Recall Bulletin

SUBJECT: Loss of Battery Charge – Inspect Generator Control Module

MODELS: 2012-2013 Buick LaCrosse, Regal
2013 Chevrolet Malibu Eco
Equipped with eAssist

Parts required for this recall have been removed from Product Quality Center (PQC) restriction. Additional part numbers and a part inspection procedure have been added to this bulletin. Please discard all copies of bulletin 13136.

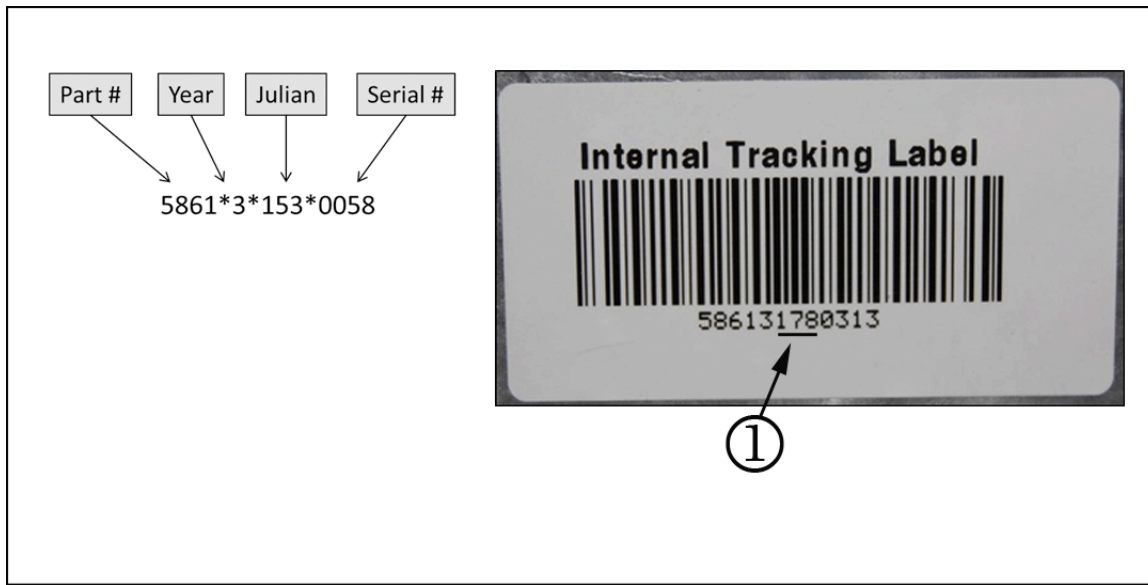
Do NOT provide technicians with GCMs (p/n 24269448 or 24266403) that have a Julian date of 171 through 199. Determine the Julian date following the steps below. Return modules that fail the inspection according to Special Return Bulletin #G_0000171850.

1. Locate the barcode label on the new GCM.

2. Determine the Julian date (1) as shown above.
 - If the Julian date (1) is 171 through 199, do NOT install the module. Obtain another module and perform the inspection again.
 - If the Julian date (1) is NOT 171 through 199, provide to the technician for installation in the vehicle.

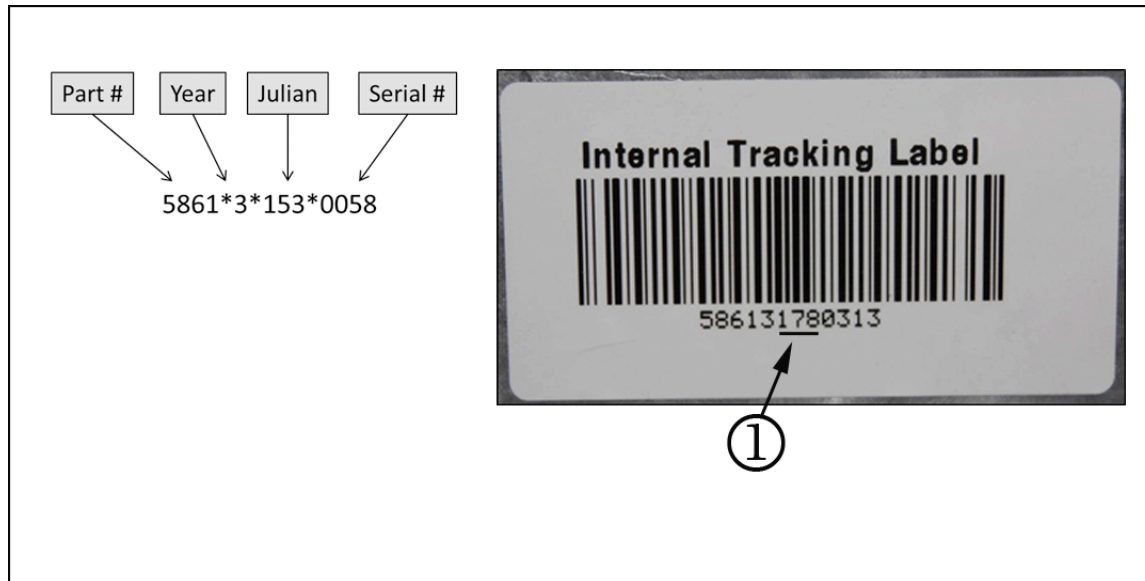
Note: Do NOT install GCMs with a Julian date of 171 through 199. Return those modules according to Special Return Bulletin #G_0000171850.

3. Locate the barcode label on the new GCM.
4. Determine the Julian date (1) as shown above.
 - If the Julian date (1) is 171 through 199, do NOT install the module. Obtain another module and perform the inspection again.

- If the Julian date (1) is NOT 171 through 199, the module can be installed in the vehicle.
1. Install GDS2 to vehicle. Start engine and confirm the vehicle has enough fuel for the drive cycle and 2 hour idle test. A quarter-tank of fuel is required to complete the test. Add fuel as required.
